Nr. inreg.: 37463 / 21. OCT. 2016

Referința: clarificari 3 DIALOG COMPETITIV – ETAPA I, organizat de CONPET SA in vederea atribuirii contractului de realizare a unei instalatii (sistem) pilot pentru detectarea si localizarea scurgerilor de produs din sistemul de conducte Poiana Lacului-Siliste-Ploiesti (proiectare, furnizare, instalare, configurare, testare)

Reference: Clarification answers 3 – COMPETITIVE DIALOGUE, organized by CONPET SA in view of awarding the works contract „execution of a pilot LDS for Poiana Lacului-Siliste-Ploiesti oil pipeline (design, supply, installation, configuration, testing)”

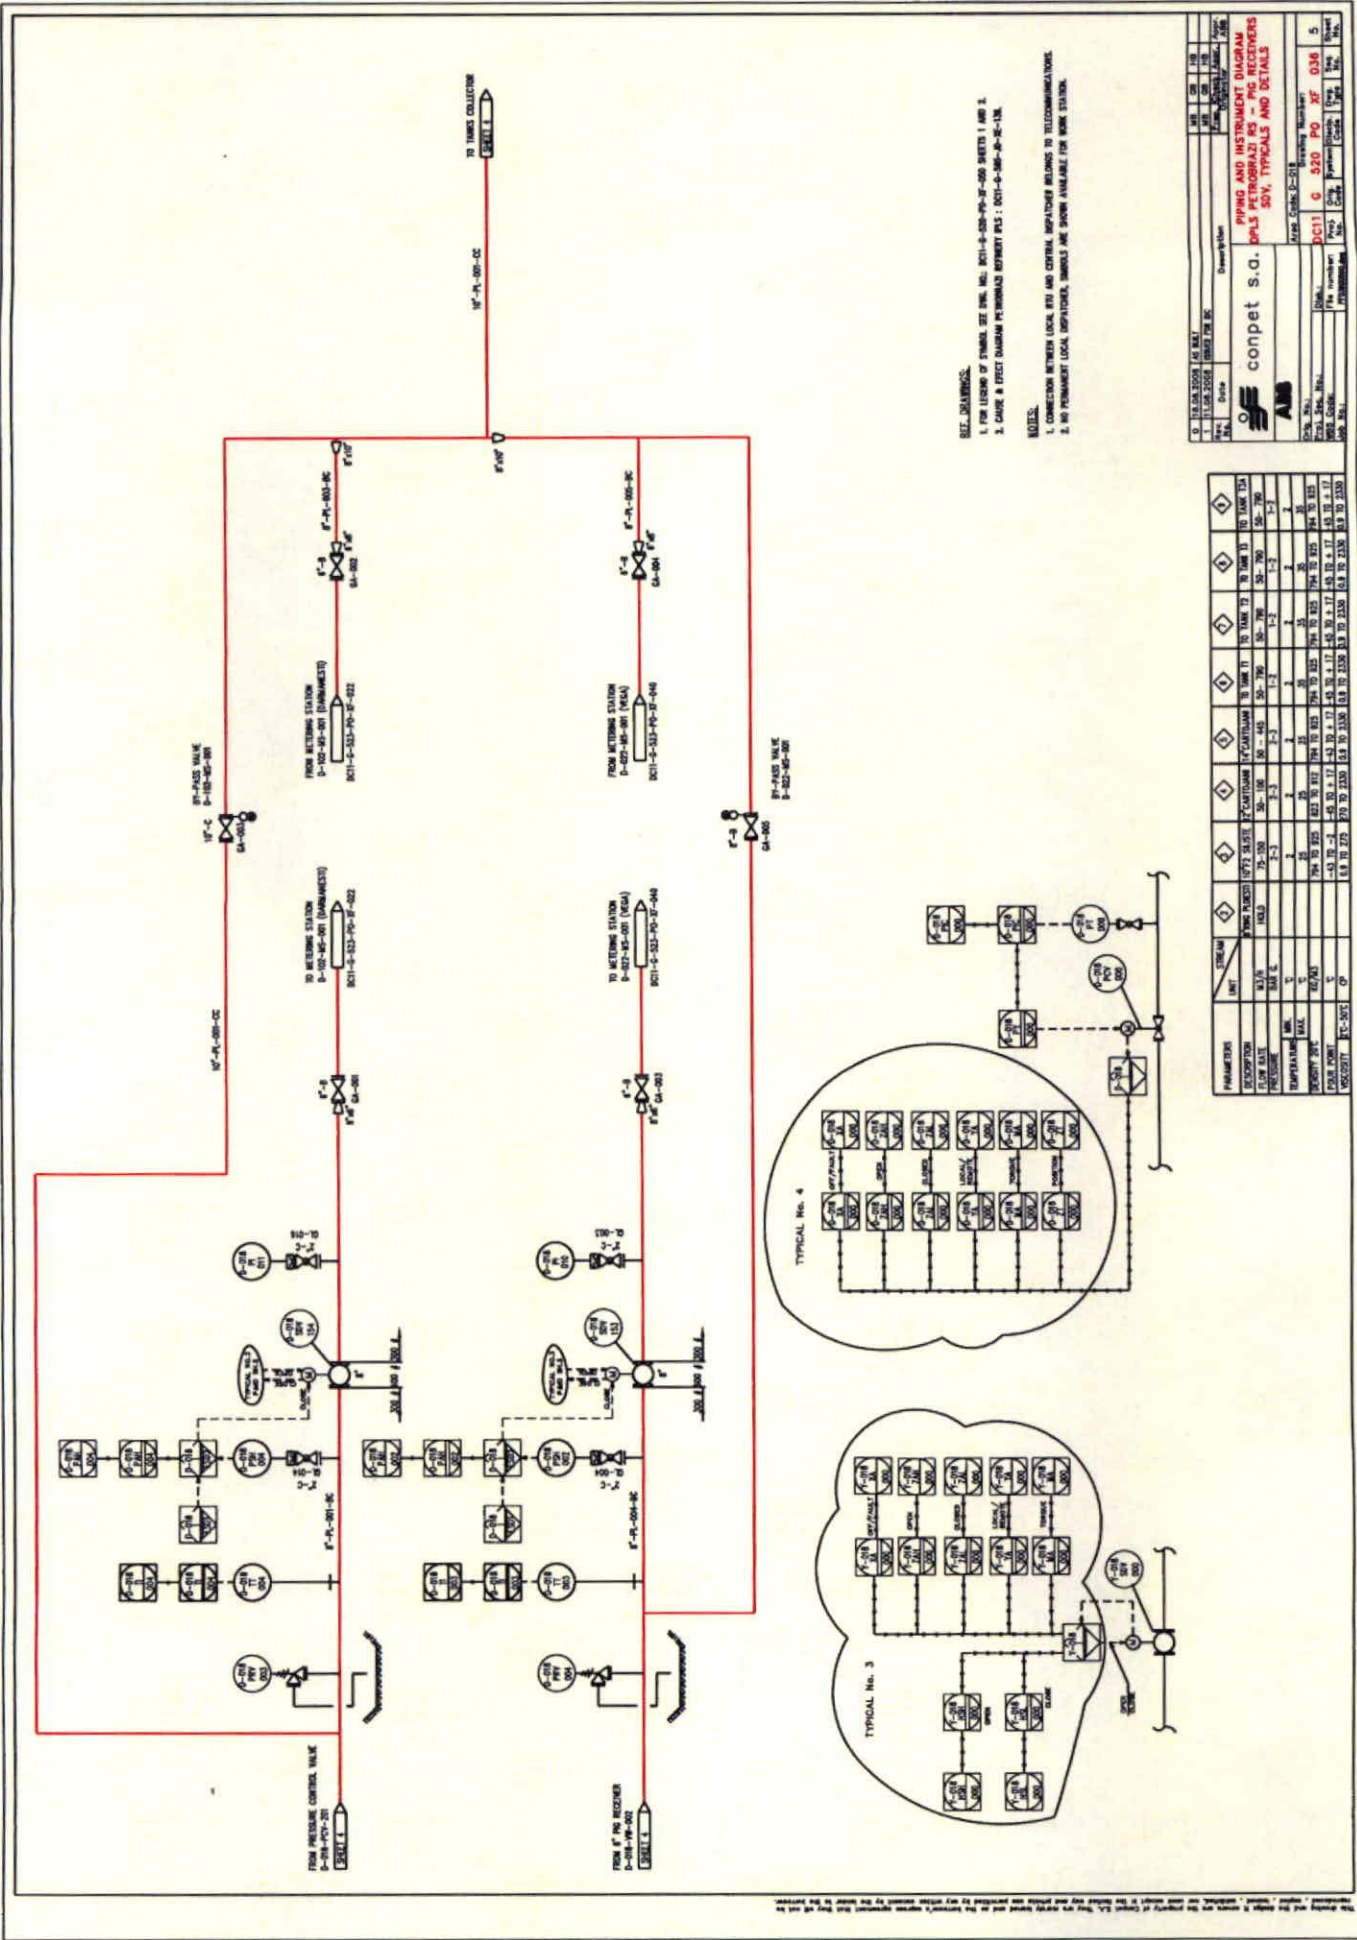
1. Question: Could we get a more detailed pipeline map showing block valve stations, Scraper stations, pump stations, Cathodic Protection station and the type of station: e.g. underground/over ground or building and if possible P&ID diagrams? We would like to know if and where to install our LDS controllers and high precision measurement equipment.

Ne puteti transmite informatii detaliate cu privire la statiile de pompare (numar de pompe per conducta, tip, putere si capacitate/debit)?

Could we get also some more detailed information about pump stations (number of pumps per pipe, type, power, and throughput)?

Answer: There are no “block valve station” on the pipeline. There is isolation buried hand valves mainly on crossings. There are scraper stations only in Poiana Lacului, Siliste on F1 and F2 inlet and outlet and Petrobrazii on F2 on the inlet. Pipeline are buried except the river crossings. There are buildings only in Poiana Lacului and Siliste. Please receive the attached available PFD’s (pump type, capacity in cm/h, head, npsh a.s.o.).

Answer: The attached PFD's contain the number, type and capacity of pumps (flow). The three screw pumps (F2) from Poiana Lacului with the nominal power of 200KW and the two centrifugal pumps (F1) with the nominal power of 132KW. Oarja has a piston pump with the nominal power of 80 KW, Saru 2 PCP (positive cavity pump) pumps with the capacity of 66 cm/h and the nominal power of 90 KW. Bucsani has 2 PCP pumps, 30cm/h with the nominal power of 37KW.
